5 September 2024

SLR Project No.: 402.064843.00001

**RE: Discharge of conditions 7, 8, 9, 16 of full planning permission F/19/86233
Land to the North and East of Boorley Green, Winchester Road, Botley, SO32 2UA**

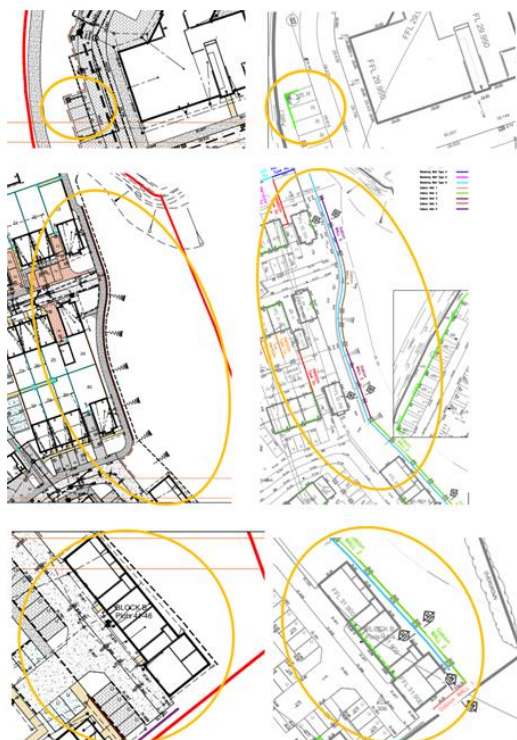
The key on the Hard Landscaping drawings indicates the gabion retaining walls are depicted by a pink line and the Retaining Wall Layout indicates that there are 5 types of gabion walls.

The hard landscape drawings do not show gabion walls in the following instances – to the west of the retail unit and on the eastern boundary.

The plans do need to be consistent with each other and the planting plans also need to be amended to show the position of the gabion walls. In addition, while it is noted that the gabion walls cannot be repositioned it was previously asked that if they could not be re-sited to allow for planting in front then the planting plans should amended to add planting along the top of the wall to soften the structures. This has not been done.'

Please see updated hard landscape plans VYH23647 12C-Sheets 1-4
